# REGIONAL REVIEW NOTICE

ARC REVIEW CODE: R1407181

**Name of Proposal:** The Heights at Sandy Springs

**SUBJECT:** **Transportation Division Review of DRI # 2419**  
Project: The Heights at Sandy Springs  
County: Fulton  
Location: South-East Corner of Roswell Road and Franklin Road  
Analysis:  
Expedited ☐  
Non-Expedited ☒

DRI SITE PLAN (DRI #2419)  
THE HEIGHTS AT SANDY SPRINGS  
LAND LOT 94 - 17th DISTRICT  
CITY OF SANDY SPRINGS  
FULTON COUNTY, GEORGIA

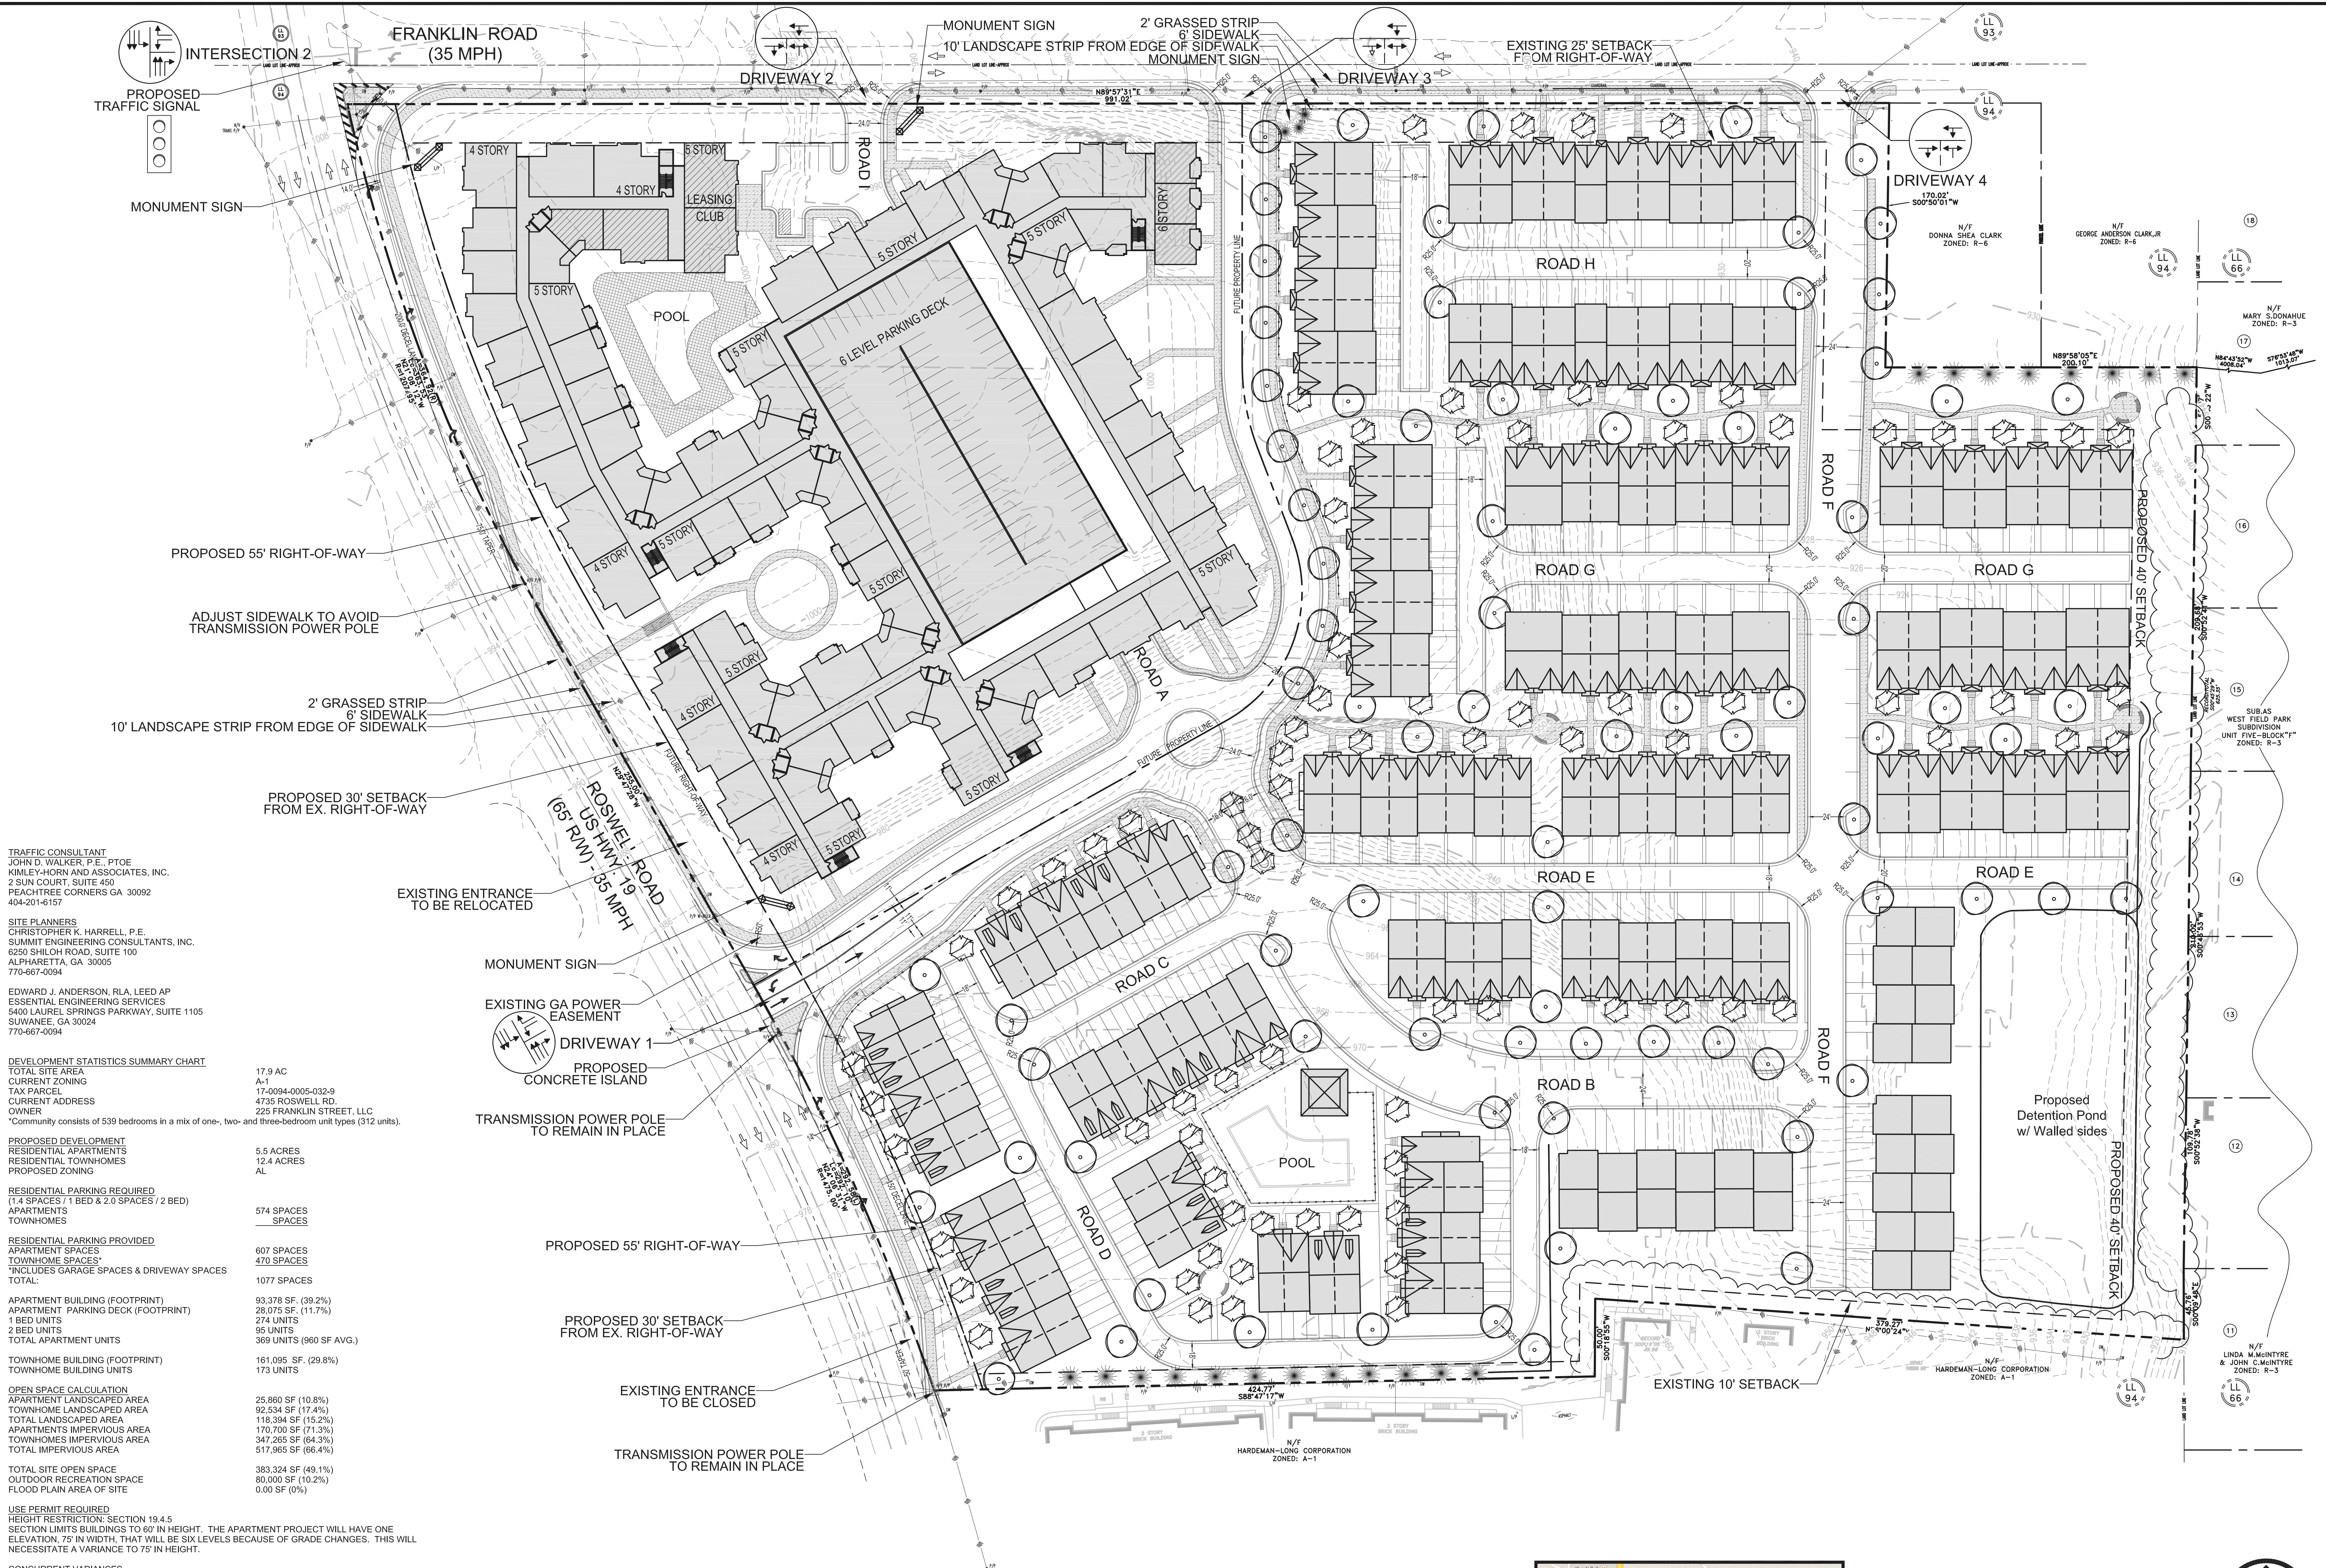
- The site plan shows a transmission power pole to be located in the triangular island for the northbound approach, which poses a concern for pedestrian movements (including persons with disabilities), and poses as a potential hazard for vehicles entering the site if control is lost by drivers due to inclement weather, etc.
- Study the potential to align main entrance on Roswell Road with the entrance to the townhome community across the street.
- A MARTA representative expressed a potential interest in moving the NB bus stop to the north in order to be closer to proposed HAWK signal and crosswalk which were proposed by the developer during the pre- pre-review DRI meeting.

- Internal site connectivity for pedestrians should include sidewalks and/or paths designed to accommodate safe movement for elderly persons and persons with disabilities between the different uses. The site plan shows paths in the townhome portion of the site, but no paths in the area around the pool and amenities.

- Ensure that public safety vehicles can access the townhome area and have enough room for movement within the central roundabout.
